PITT-03-19-039

Re: Incompleteness Review Responses
E07-459 Major Amendment
Application No. E07-459
APS No. 879354
Woodbury Township, Blair County

Comments and Responses to March 7, 2019 Incompleteness Review Letter

Piney Creek Reroute Major Permit Modification

FIGURE 1

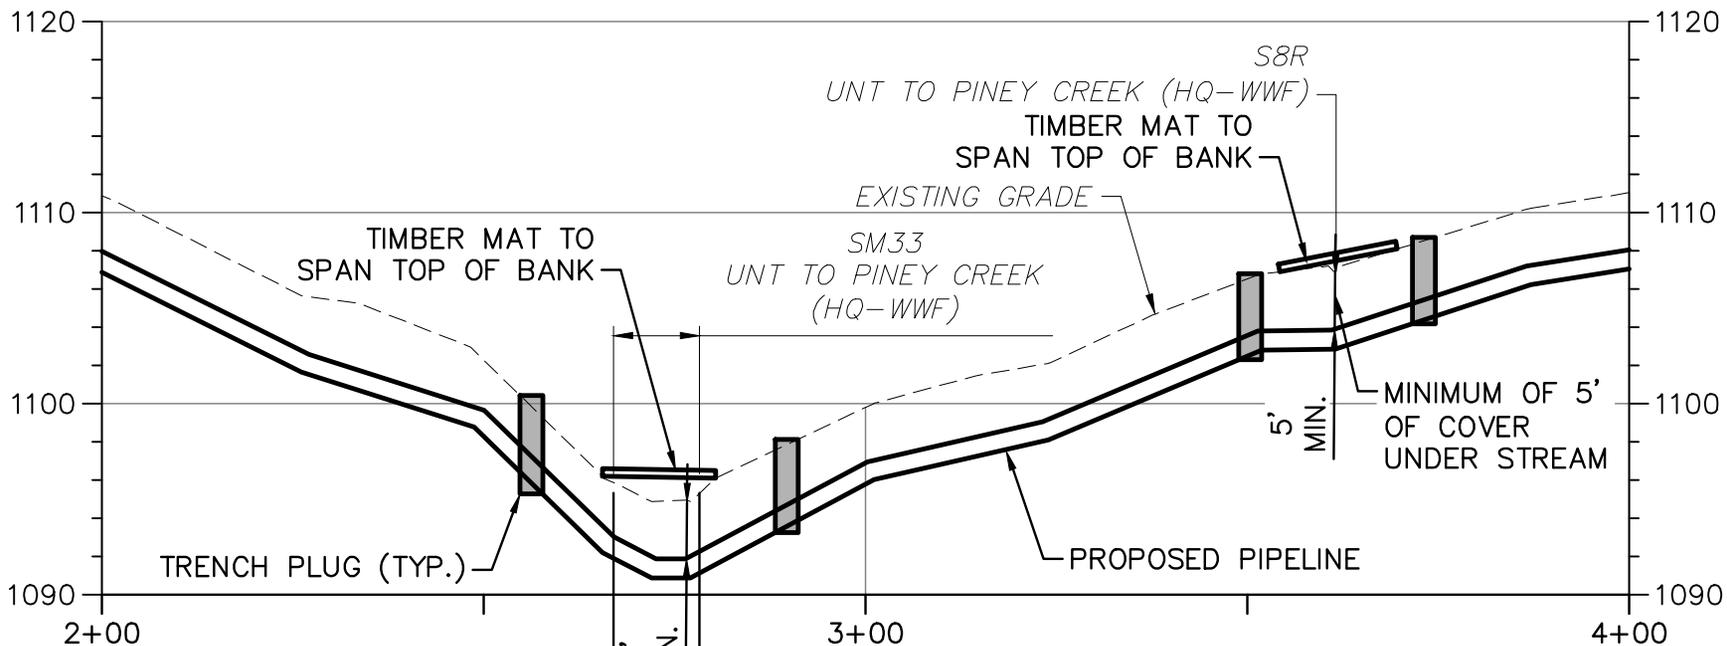
4.	Provide a profile view for each resource being crossed on the proposed alignment. <i>[Instructions 3150-PM-BWEW0036, Section F.h (3)]</i>	Attachment D of this response provides the profile view for each of the stream resources crossed by the proposed modification/reroute.

SM33 CHANNEL DATA	
TOP OF BANK (TOB)	10'
CHANNEL DEPTH (CD)	3'
WATER WIDTH (WW)	10'
WATER DEPTH (WD)	4"
